Product Change Notification PCN-BUR-00194

Subject: Eaton's Bussmann series CHPV15H85 Fuse holder

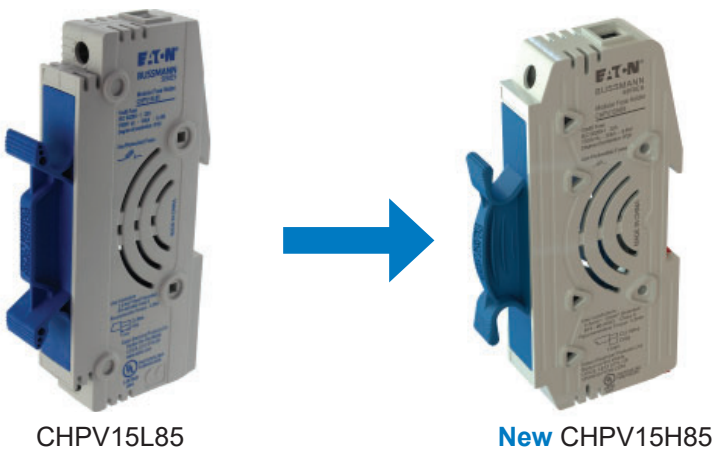
As part of Eaton's commitment to continuously improve its global product line, we are pleased to inform you that Eaton's Bussmann series 1500 V d.c. 10 x 85 mm fuse holder, part number CHPV15L85, will be replaced by our new version **CHPV15H85**.

Our new fuse holder is a direct replacement: the physical footprint, the technical performance and agency approvals are similar to the CHPV15L85. The only difference is the pack quantity: the CHPV15L85 comes in pack of 12, the CHPV15H85 will be sold in pack of 10.

The current CHPV15L85 is still fully saleable, orders can still be placed while stocks last. Once the stock of CHPV15L85 has been drained, the new CHPV15H85 will automatically be sent in its place.
